MEMO

To: Kristopher Byrd, Well Construction and Compliance Section Manager
From: Travis Kelly, Well Construction Compliance Coordinator
Subject: Review of Water Right Application G-19038
Date: February 16, 2022

Application # G- 19038

TO: Water Rights Section Date 1/18/2022
 FROM: Groundwater Section Stacey Garrison/Travis Brown
 Reviewer's Name
 SUBJECT: Application G- 19038 Supersedes review of _____
 Date of Review(s) _____

Water-Level Measurements in Nearby Wells

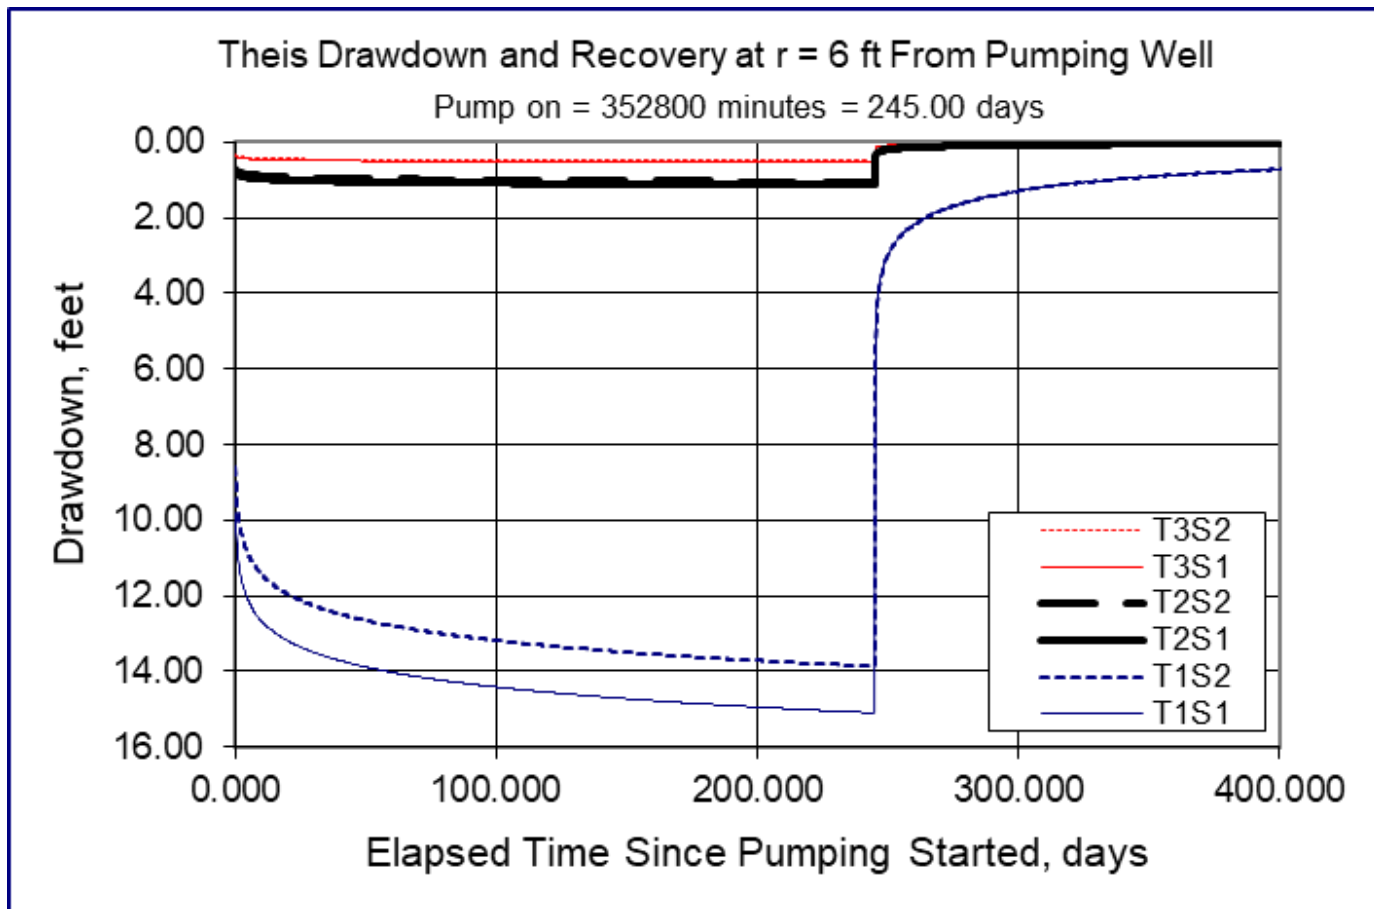
The existing POA (CLAC 70813) utilizes a water-bearing zone within the Columbia River Basalt Group (CRBG); aquifers in the CRBG are typically thin interflow zones between lava flows and confined by thicker flow interiors that have low porosity and low permeability (Conlon et al 2005, Gannet and Caldwell 1998, Reidel et al 2002). Comparison of the POA well log with local lithology indicates the POA likely utilizes water from the Frenchman Springs member of the Wanapum Basalt, or the Grand Ronde Basalt given the extent of anticlinal activity in the area (Anderson 1978, Madin and Staub 1994, McFarland 1996, Madin 2004). The POAs are located within the Portland Hills-Clackamas River Fault Zone, which is deformed by predominantly southeast by northwest trending faults, possibly resulting in compartmentalization of aquifers (Anderson 1978, Madin and Staub 1994). There is a northwest trending fault less than a mile to the northwest of CLAC 70813 (Madin 2004). The degree of compartmentalization due to nearby faults, which is unknown at this time, may exacerbate well-to-well interference and longer-term water level declines in the local basalt aquifer.

A review of statistics for nearby well records was completed and compared with the proposed rate of 0.22 cfs (100 gpm) for this application (see Well Statistics 2S/3E). There is some uncertainty regarding the ability of the groundwater resource to sustain the proposed use of 0.22 cfs (100 gpm); median reported well yield is 20 gpm, however, the proposed rate is less than the maximum reported yield of 545 gpm. The proposed rate for this application is 500 percent of the median, and 18 percent of the maximum reported yield. However, few of these wells appear to be in the CRBG. Previous studies have reported yields for wells utilizing the CRBG in the Clackamas River drainage ranging from 20 to 350 gpm (Leonard and Collins 1983). Water level trends for nearby wells that utilize the CRBG appear to be stable (see Water Level Measurements in Nearby Wells). Two of the wells, CLAC 56352 (~ 9.9 miles to the southwest) and CLAC 20274 (~ 10.3 miles to the southwest) show relatively stable water levels. One of the wells, CLAC 18421 (~8.2 miles to the southwest) shows a steady but moderate decline. The last well, CLAC 59771 (9.8 miles to the southwest), has 3 datapoints, so it is difficult to make any interpretations of trends.
